02/05/99

Errata: CS4954/55 Rev. B(Reference CS4954/55 Data Sheet revision DS278PP3 dated Jul '98)

D) PACKAGE DRAWING for the 48L TQFP page 59

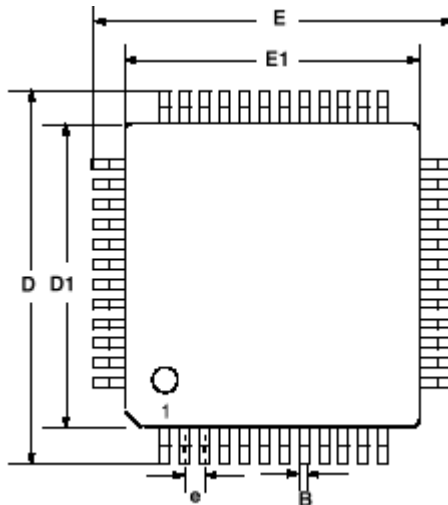
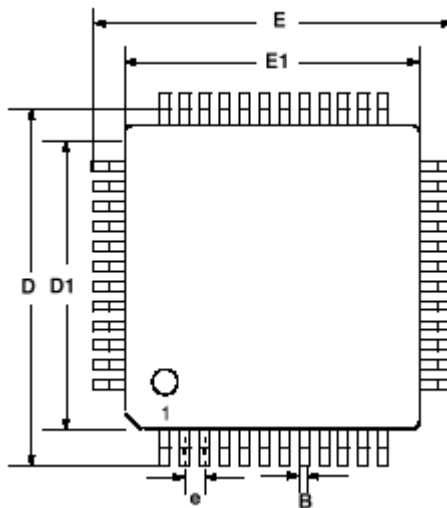
While the specification table for this package is correct, the drawing itself should be adjusted to accurately show measurement 'D' and 'D1'

SHOULD READ:
